Device Errata

MPC801

Silicon Revision A.2 - Mask Set F87S
May 18, 1998 (Version - 4)

G5. Potential problems caused by skew between EXTCLK and CLKOUT.

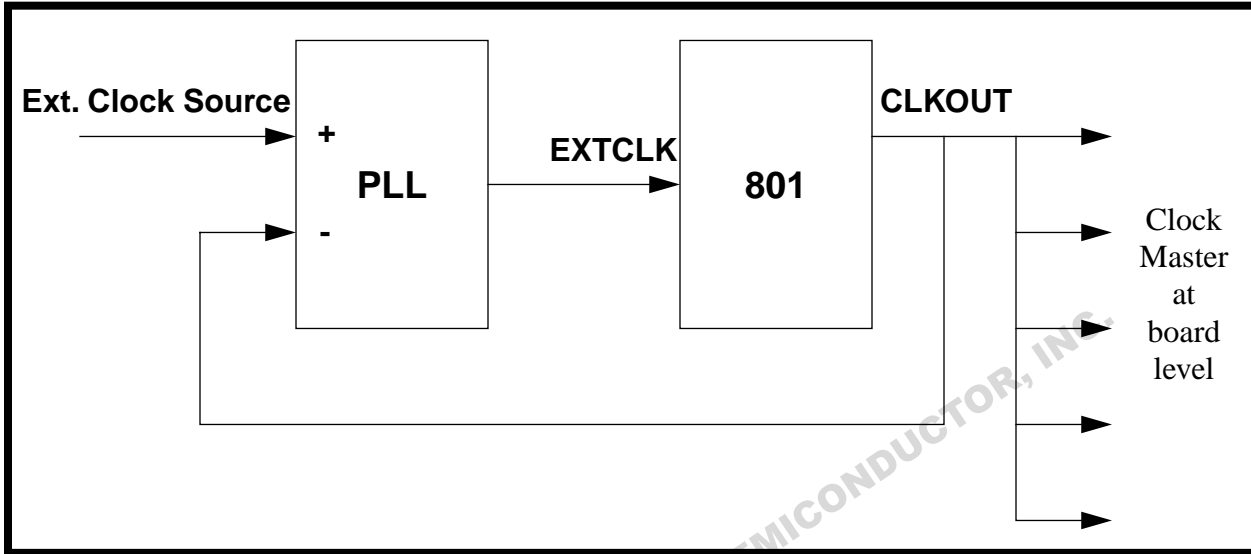
The PLL of the MPC801 locks on the falling edge of the input clock EXTCLK. This will affect the skew between EXTCLK and CLKOUT at the rising edge. The skew is dependent on the duty cycle of the input clock (but for a 50% duty cycle will not exceed 2nS). This will affect synchronous designs where the same clock source is used as an input to EXTCLK, as well as to an external synchronous device (e.g. a peripheral or ASIC).

Case 2. Where it is necessary to synchronize an external master clock (e.g. from a backplane), an MPC801, and external peripherals, to allow data transfers in all three directions:

[NOTE: This workaround is a concept only. It has not been verified in hardware.]

Insert a PLL between the external master clock and the EXTCLK pin of the MPC801. Connect the phase comparison pin of the PLL to the CLKOUT pin of the MPC 801. Also use the CLKOUT signal as the reference clock for distribution to the local external peripherals.

Important Note: The PLL has to be capable of operating with a permanent offset of -2nS, therefore the range of lock should extend to about -4nS.

A diagram of this concept is given below:
